GW – 269

Re: Southern Union Gas Services/Boyd Compressor Site GW-269

Re: GW-269, Boyd Compressor Station, Below Grade Tank Work Assessment

Schematic for location of monitor wells

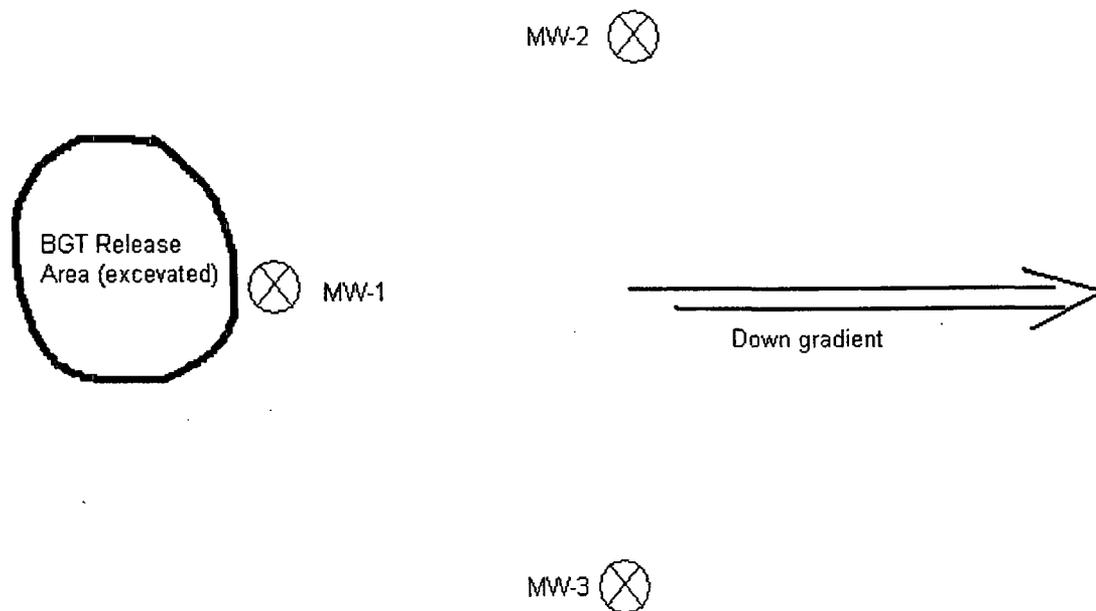
The Environmental Bureau of the New Mexico Oil Conservation Division (NMOCD) has received the site follow up report for the release at the Boyd compressor station dated December 15, 2008, and has conducted a review of the report. The OCD hereby approves the anticipated actions at the site as specified in the report. However, the OCD recommends locating the groundwater monitor wells as specified below (see attached schematic for details):

MW-1, down gradient and adjacent to the localize area of the release, but not close enough to penetrate through the 30 Mil liner.

MW-2, down gradient of the release.

MW-3, down gradient of the release.

Southern Union Gas may place a monitor well up-gradient of the incident but are not required to. The initial sampling should include the parameters specified in the attached list.

Schematic for location of monitor wells

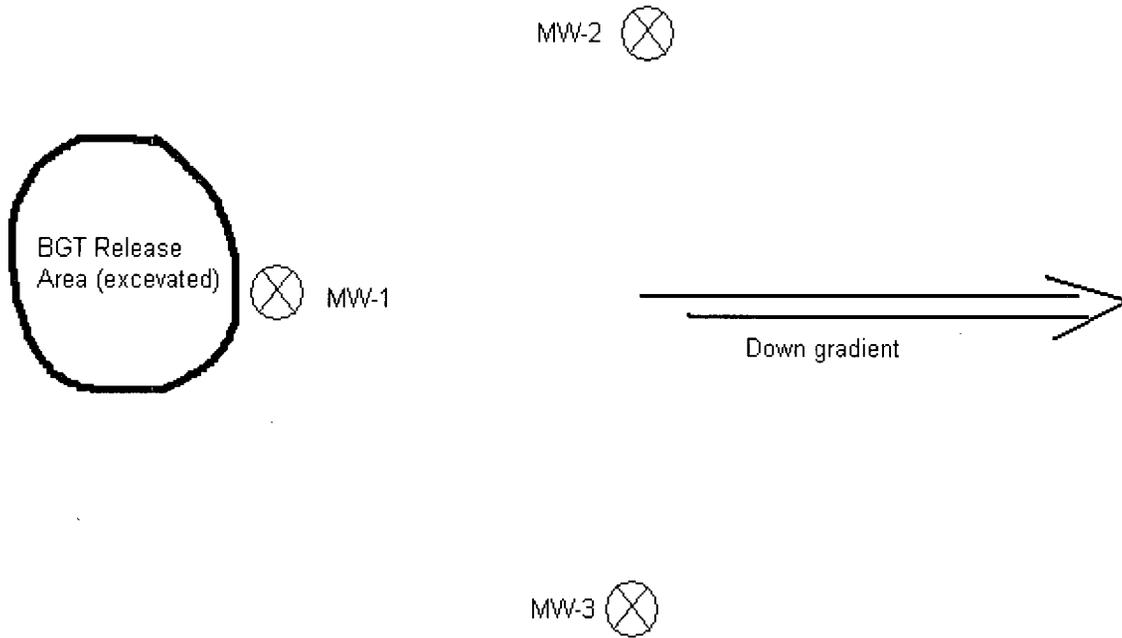
The Environmental Bureau of the New Mexico Oil Conservation Division (NMOCD) has received the site follow up report for the release at the Boyd compressor station dated December 15, 2008, and has conducted a review of the report. The OCD hereby approves the anticipated actions at the site as specified in the report. However, the OCD recommends locating the groundwater monitor wells as specified below (see attached schematic for details):

MW-1, down gradient and adjacent to the localize area of the release, but not close enough to penetrate through the 30 Mil liner.

MW-2, down gradient of the release.

MW-3, down gradient of the release.

Southern Union Gas may place a monitor well up-gradient of the incident but are not required to. The initial sampling should include the parameters specified in the attached list.
